SOLICITATION ADDENDUM NO. 2

ITB 22-0019

New Generators- Fir Grove Elementary/Sexton Mountain Elementary

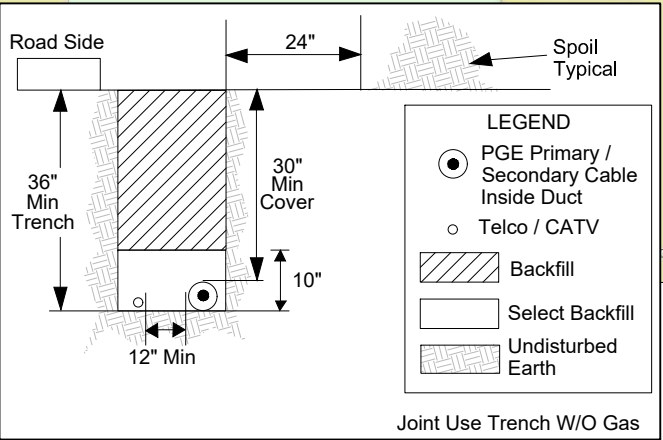
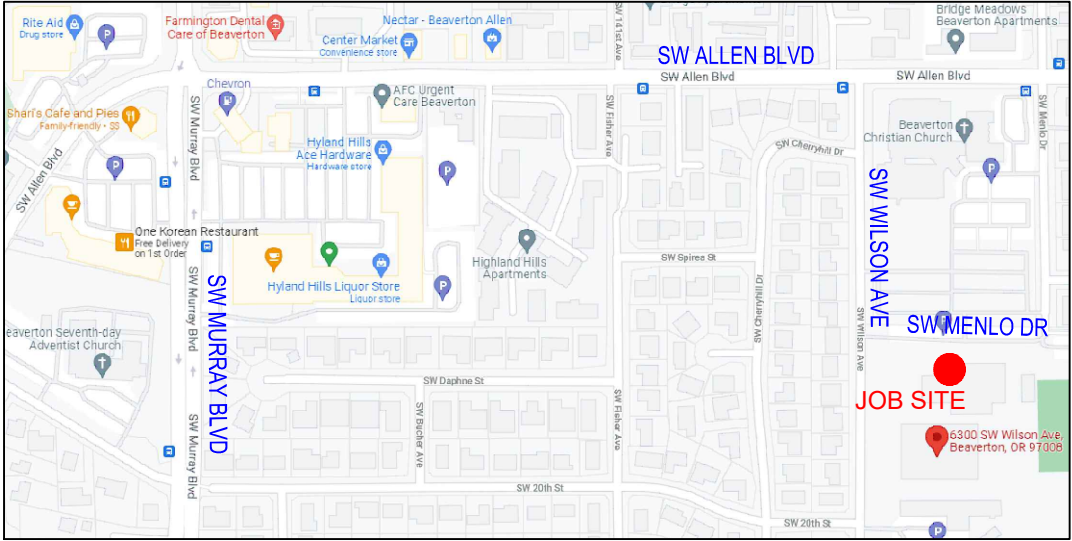
Question: Please confirm AIC rating for the Fir Grove 800A service and downstream equipment.

Answer: **I have done some calculations that the gear will be under 22,000 AIC with 3-75 KVA transformers on the pole. I will need to confirm this with PGE in the near future. See attached.**

ATLAS LOUVERED SWING GATES

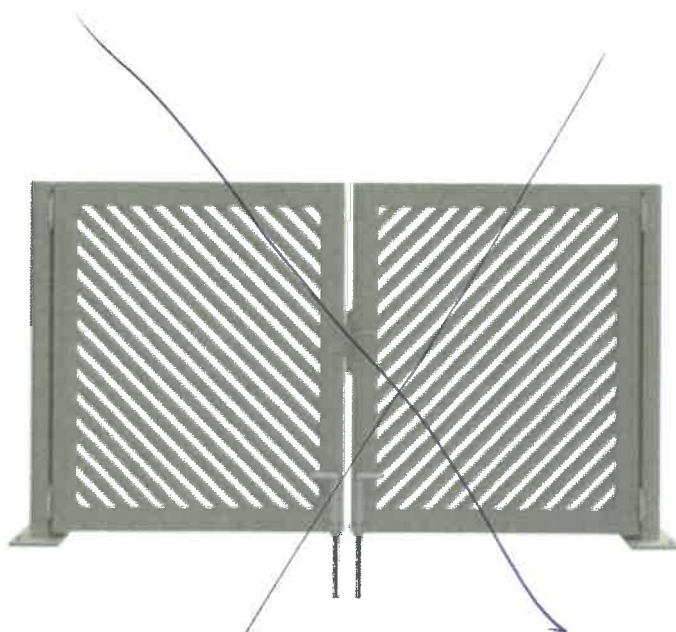
Question: Sexton Mnt: Sheet E1 Note 12 references Panshield. Can not find any product data or reference online for this. Please specify manufacturer, gauge, style, and gate size.

Question: Sexton Mnt: Sheet E1 detail 3 – Post Size & Height

Answer: **See attached Sexton Mountain generator fence info.**

Answer: **See attached Sexton Mountain generator fence info.**
